City Of SeaTac Departure Request Worksheet

PROJECT NUMBER 24.343

DESCRIPTION
ZONING CODE ANALYSIS -
DEPARTURES

SOUTH ELEVATION - DEPARTURES

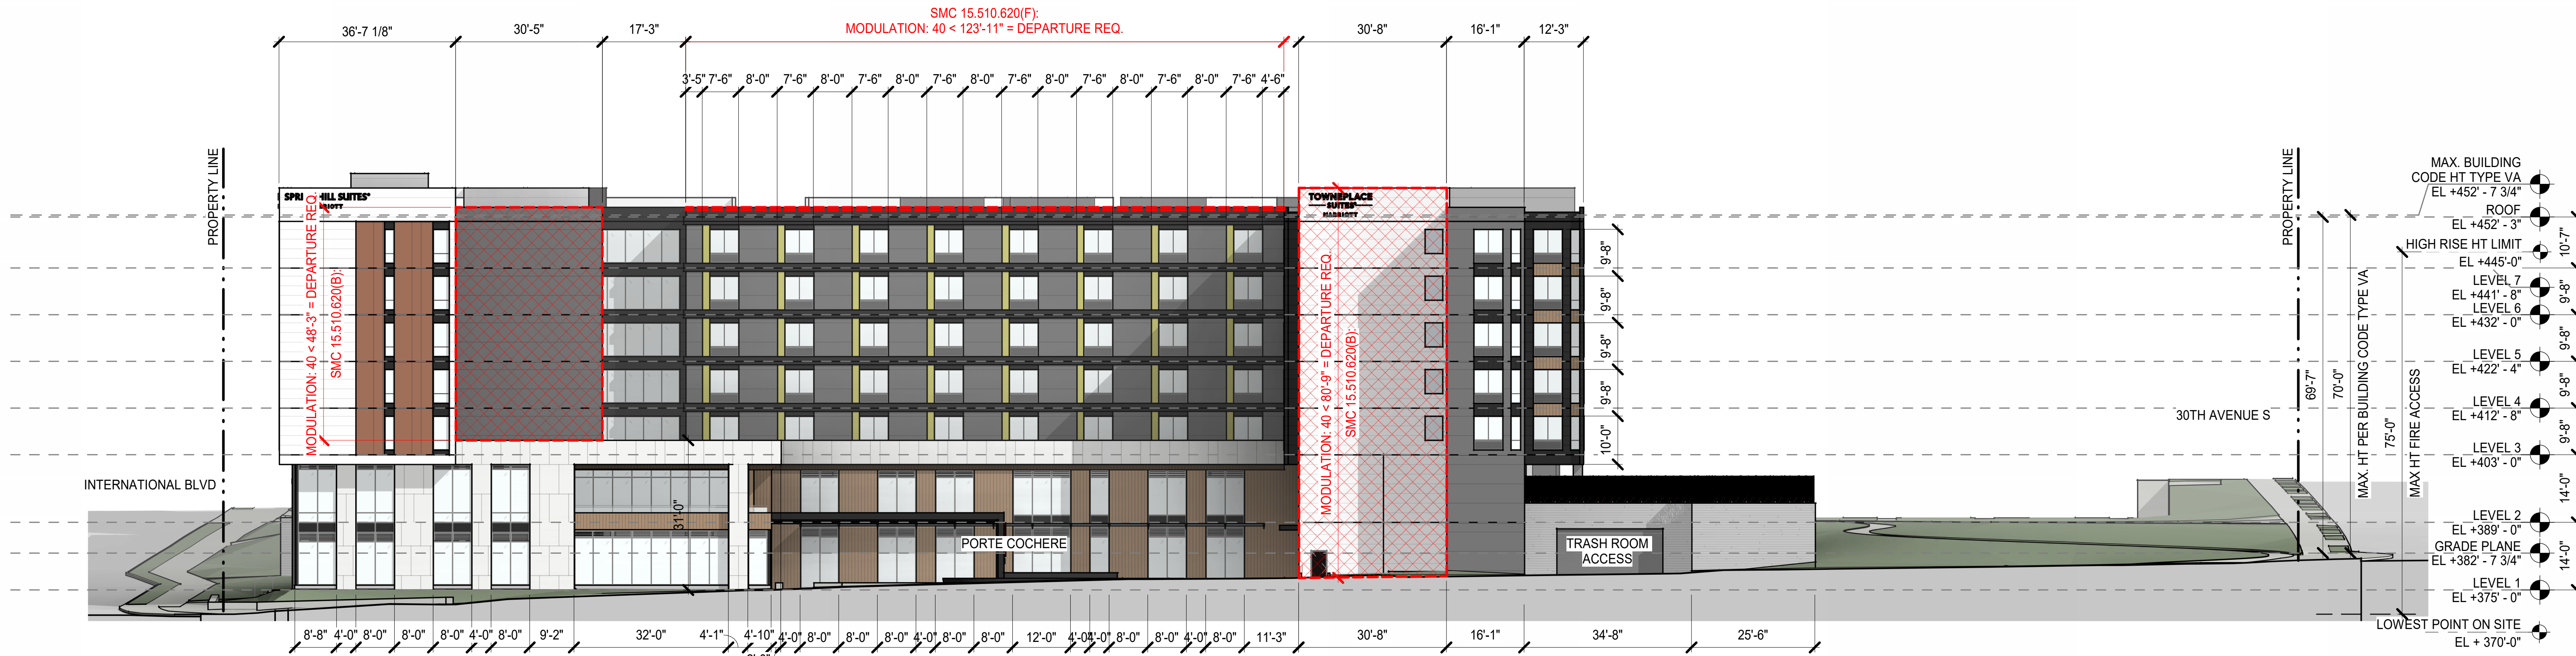
DEPARTURE 3 - SMC Development Standard(s): SMC 15.510.620(F) Rooflines

We are requesting a departure to allow portions of the roofline to extend beyond the standard maximum length of 40 feet.

The project features a contemporary flat roof design enhanced by an variety of articulated parapets that differ in height and length. These parapets introduce rhythm and depth to the building, effectively breaking down the massing and creating a visually compelling roofline. Rather than relying on traditional pitched forms or dormers, the design employs modern architectural language to achieve the same intent - reducing perceived scale and adding visual interest.

WEST ELEVATION - DEPARTURES

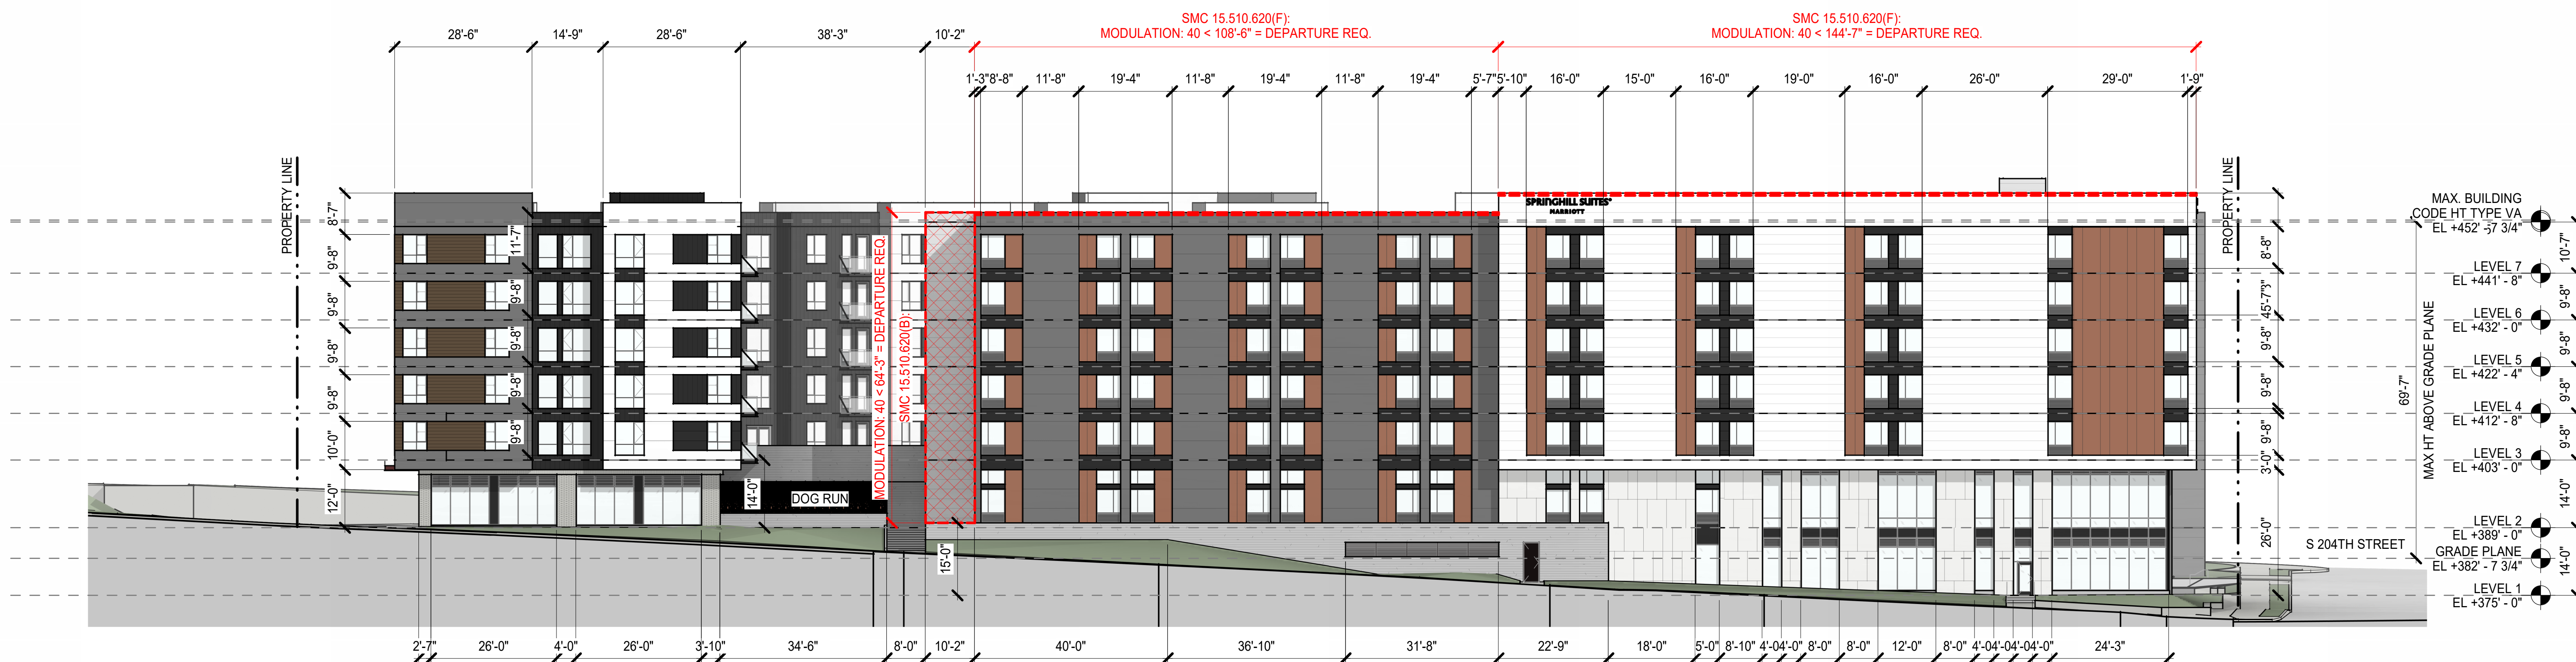
DEPARTURE 2 - SMC Development Standard(s): SMC 15.510.620(B) Vertical and Horizontal Variation

We are requesting a departure from the requirement that vertical and horizontal modulation of the building occurs at intervals no greater than 40 feet.

The design exceeds the 40 foot modulation intervals to emphasize the building's proportions and support a more elegant and contemporary architectural expression. To maintain visual interest and reduce perceived scale, the facade incorporates a range of strategies - including window articulation, material variation, and balconies that work together to break up the massing and create a dynamic street presence.
